## 8 SUMMARY OF POTENTIAL DS2 FAILURE MODES

## 8.1 DS2 Failure Mode Assessments

## 9 DS2 DISCIPLINE AREA ASSESSMENTS

**Figure 8-1. DS2 Entry, Descent, and Impact Sequence with Potential Failure Modes**

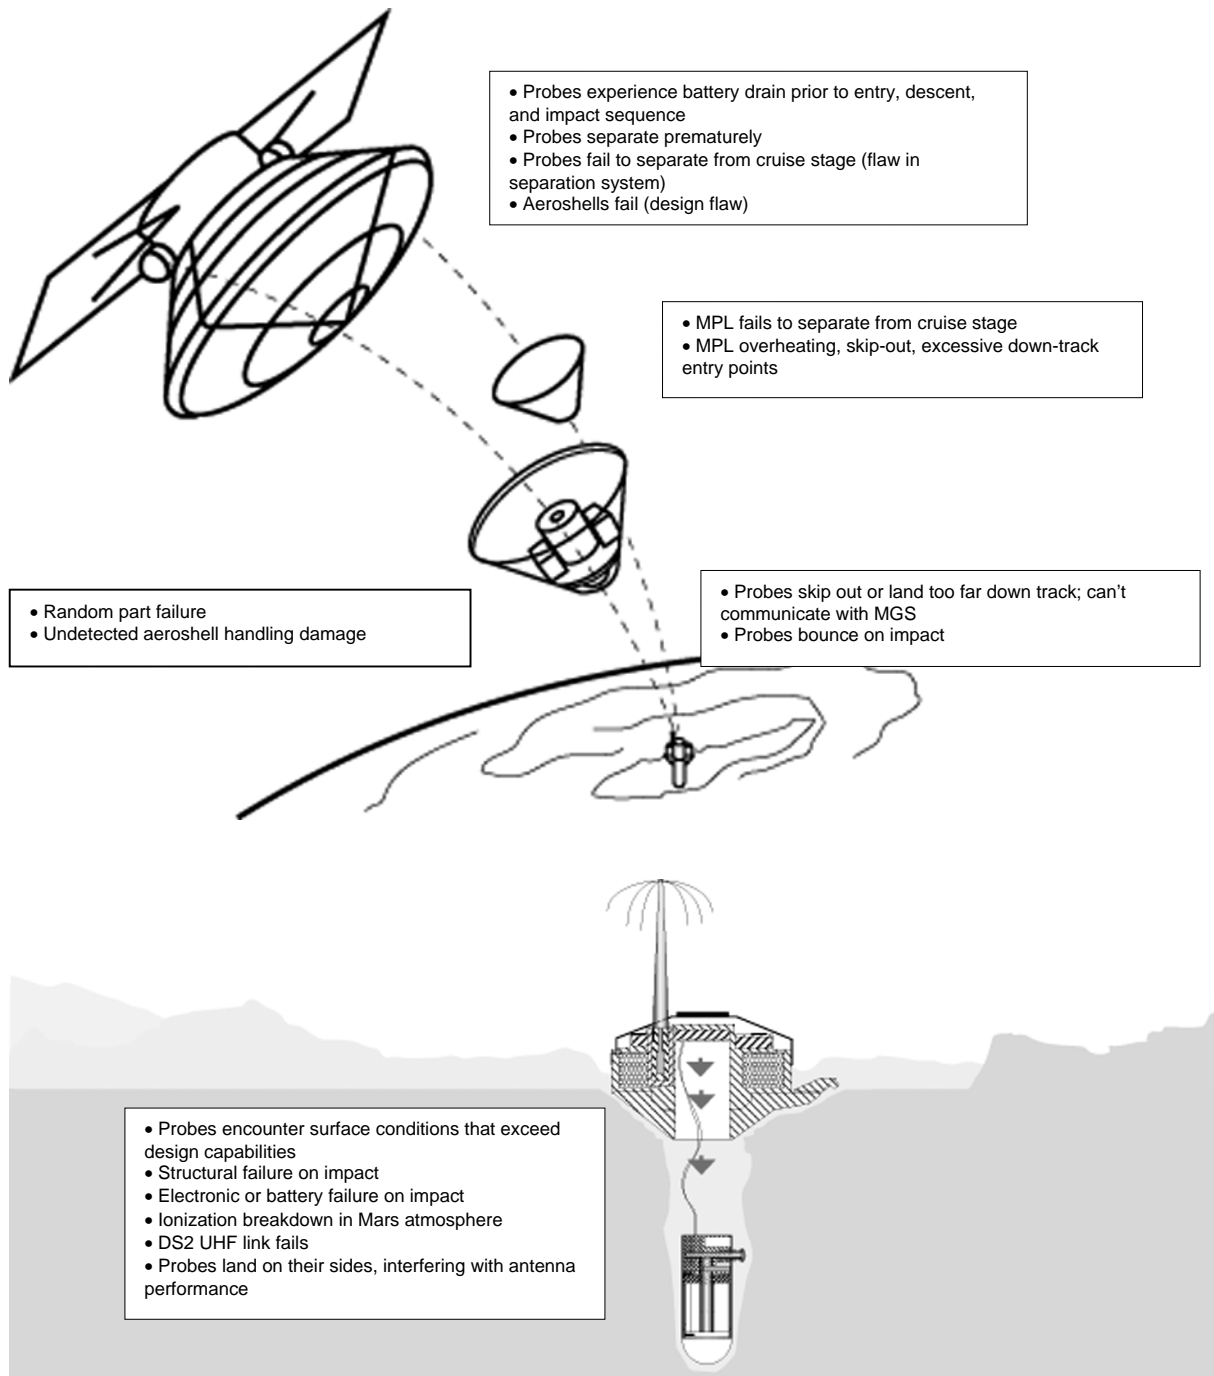
The four DS2 potential failure modes identified by the Board as plausible are highlighted as *FLAG 1*, *FLAG 2*, *FLAG 3*, and *FLAG 4*.

Figure 8-1 illustrates the DS2 entry, descent, and impact (EDI) sequence and shows potential failure modes.
